AMENDMENTS TO THE DRAWINGS

REMARKS

FIG. 2
(PRIOR ART)

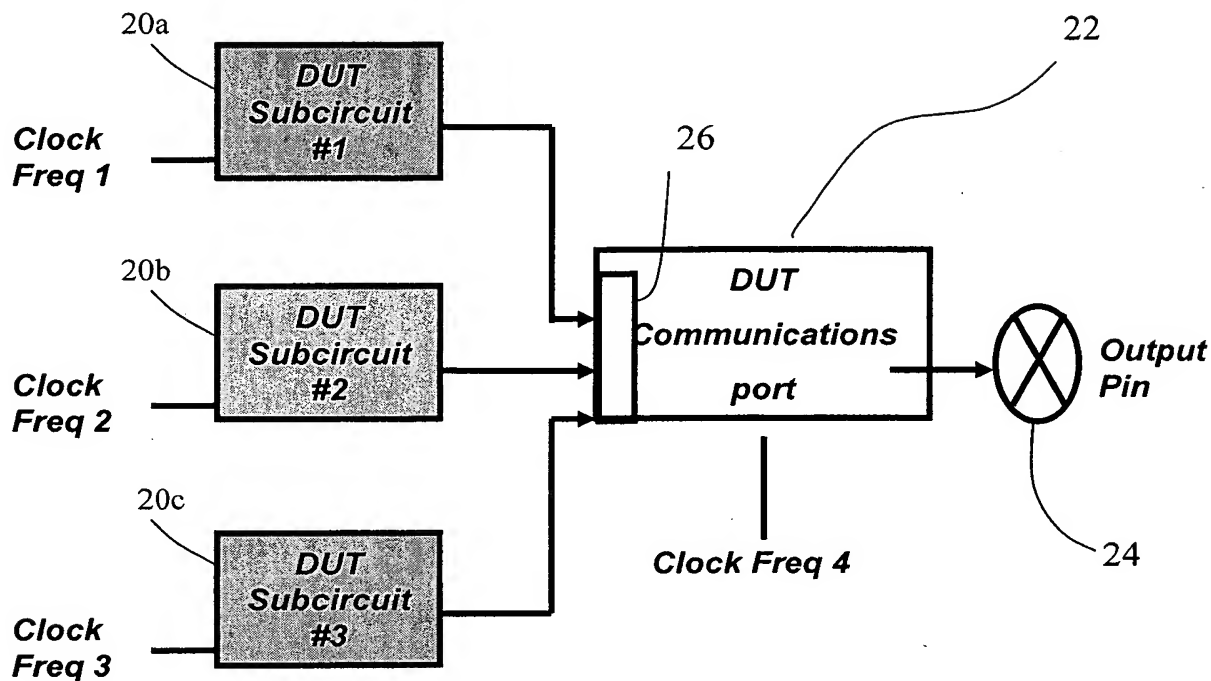
The attached sheet(s) of drawings includes changes to Figures 2 and 3.

The Examiner has objected to FIGS. 2 and 3 because the legend does not indicate the figures show the prior art. The enclosed replacement sheet should remove this objection.
